## HISTORIC AND DESIGN REVIEW COMMISSION

**HDRC CASE NO:** 2017-595  
**ADDRESS:** 205 OSTROM  
**LEGAL DESCRIPTION:** NCB 6938 BLK LOT 1&2  
**ZONING:** R-4 CD, H, RIO-1  
**CITY COUNCIL DIST.:** 1  
**DISTRICT:** River Road Historic District  
**APPLICANT:** Tobias Stapleton  
**OWNER:** Tobias Stapleton  
**TYPE OF WORK:** Construction of a two story, rear accessory structure and rehabilitation of the historic structure  
**APPLICATION RECEIVED:** November 3, 2017  
**60-DAY REVIEW:** January 2, 2017  
**REQUEST:**

The applicant is requesting conceptual approval to construct a two story, rear accessory structure. The existing, one-story historic structure on the property will be retained and rehabilitation plans will be submitted at a future date.

Front Elevation scale: 1/8" = 1' - 0"

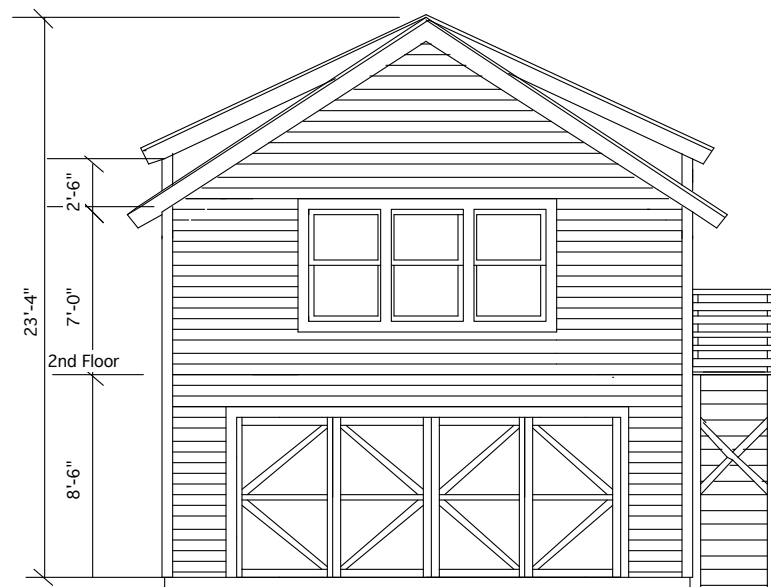
- g. **ACCESSORY STRUCTURE** – To the rear (northwest) of the primary historic structure, the applicant has proposed to construct a two story accessory structure to accommodate vehicular parking as well as a second level dwelling unit. The proposed accessory structure features an overall profile and massing that is greater than that of the primary historic structure, which features one story; however, staff finds that the proposed structure is appropriate given the proposed roof form and architectural details, which not only reduce its perceived massing, but also relate it to historic structures found throughout the district.

- ii. That the single garage door be eliminated and a two-stall configuration with two separate doors be used instead. The doors must feature materials and a profile consistent with historic examples found in the district.
- iii. ARCHAEOLOGY- Archaeological investigations may be required. The archaeological scope of work should be submitted to the OHP archaeologists for review and approval prior to beginning the archaeological investigation. The development project shall comply with all federal, state, and local laws, rules, and regulations regarding archaeology.

## Essence Double Hung Window 1 3/8" Fin Setback, 4 9/16" Wall Condition

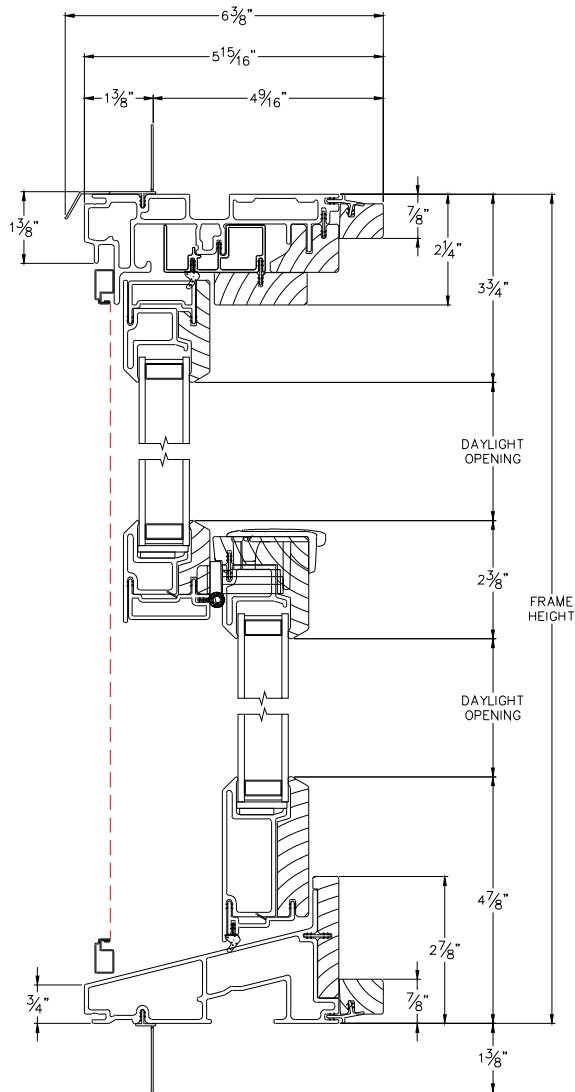
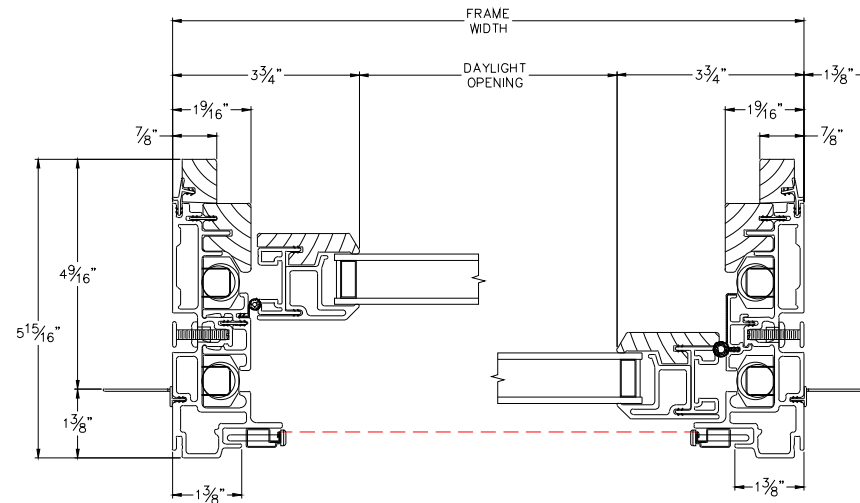
- i. That the applicant install wood or aluminum clad wood windows should be installed that feature meeting rails that are no taller than 1.25” and stiles no wider than 2.25”. White manufacturer’s color is not allowed, and color

selection must be presented to staff. There should be a minimum of two inches in depth between the front face of the window trim and the front face of the top window sash. This must be accomplished by recessing the window sufficiently within the opening or with the installation of additional window trim to add thickness. Window trim must feature traditional dimensions and an architecturally appropriate sill detail. Window track components must be painted to match the window trim or concealed by a wood window screen set within the opening.
